Wu Shan Road, Tuen Mun <u>Addendum to the Approved Planning Brief</u> (January 2022)

PLANNING BRIEF

PROJECT NAME: Wu Shan Road		
Date of Preparation: Nov 21, 2019 3:32:5		
1. Site Particulars	Current Proposal	Remarks
1.1 District Location	Tuen Mun	
1.2 Site Location	Wu Shan Road

Attachments						
Plan 1. Development	Concept Plan

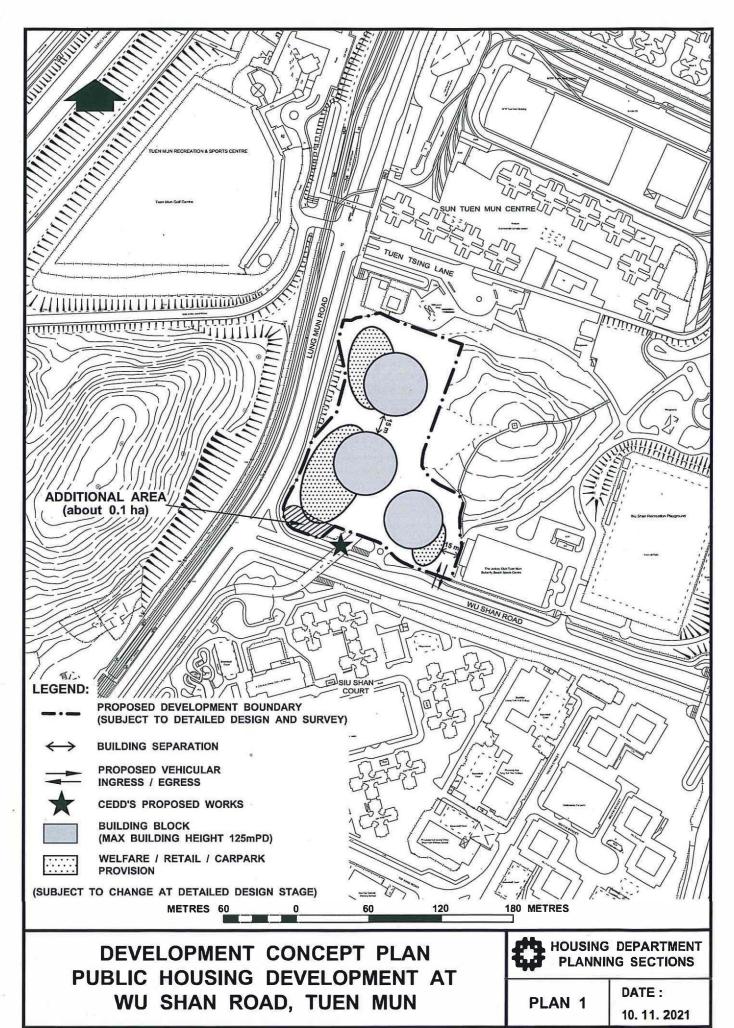
Approved Planning Brief (Date: 18 December 2019)	Proposed Amendment to the Planning Brief	Reasons for Change
Gross Site Area (approx.) (ha)	1.89	1.99	The area originally for the reprovision of the cycle ramp could be released and absorbed with the replacement of the cycle ramp by two passengers lifts as designed by CEDD. This results in a change of site area by 0.1ha. Subject to detailed survey.
Net Site Area (approx.) (ha)	1.89	1.99	The area originally for the reprovision of the cycle ramp could be released and absorbed with the replacement of the cycle ramp by two passengers lifts as designed by CEDD. This results in a change of site area by 0.1ha. Subject to detailed survey.
Proposed No. of Flats	2,938	2,646	Flat number decreased by 292 units as the project design is adjusted for more desirable flat mix with larger flat size. Subject to detailed design. A ±10% variation is allowed for flexibility at the design stage subject to pro-rata adjustments of ancillary facilities.

Design Population (approx.)	8,230	7,409	Design population decreased by 821 persons due to change in flat number. Subject to detailed design. A ±10% variation is allowed for flexibility at the design stage subject to pro-rata adjustments of ancillary facilities. Based on an average household size (AHS) of 2.8. AHS is subject to change at detailed design stage.
Maximum Domestic GFA (sq.m.)	113,400	119,400	Maximum domestic GFA increased by 6,000 sq.m. due to change in site area.
Maximum Non- Domestic GFA (sq.m.)	9,450	9,950	Maximum non-domestic GFA increased by 500 sq.m. due to change in site area.

Social Welfare / Community Facilities [no.]						
Residential Care Home for the Elderly (RCHE) cum Day Care Unit (DCU) for the Elderly	1	1	As agreed in the approved Planning Brief.			
Neighbourhood Elderly Centre (NEC)	1	1	As agreed in the approved Planning Brief.			
Special Child Care Centre (SCCC)	-	1 (60-p)	As per SWD's request, additional social welfare facilities are required, according to the Government Policy of 5% Gross Floor Area (GFA) for welfare provision as set out in Policy Address 2020. SWD proposed NOFA of about 409 sqm for SCCC which is subject to the confirmation on funding availability and detailed design. One designated parking space (12m L x 3.5m W x minimum 3.8m Headroom) for a 48-seater coach for the 60-p SCCC will be provided. The SCCC parking space will serve the L/UL purpose for the SCCC.			
One team of Home Care Services (HCS) for Frail Elderly Persons (3-team size non-kitchen based)		1	As per SWD's request, additional social welfare facilities are required, according to the Government Policy of 5% GFA for welfare provision as set out in Policy Address 2020. SWD proposed NOFA of about 207 sqm for HCS for Frail Elderly Persons which is subject to the confirmation on funding availability and detailed design. (i) One designated parking space for one private light bus with taillift measuring 8m x 3m with minimum headroom of 3.3m is required. (ii) A shared loading/unloading area for the private light bus of the HCS team for Frail Elderly Persons and other welfare facilities in close proximity to the entrance of the lift lobby to the HCS team for Frail Elderly Persons is required.
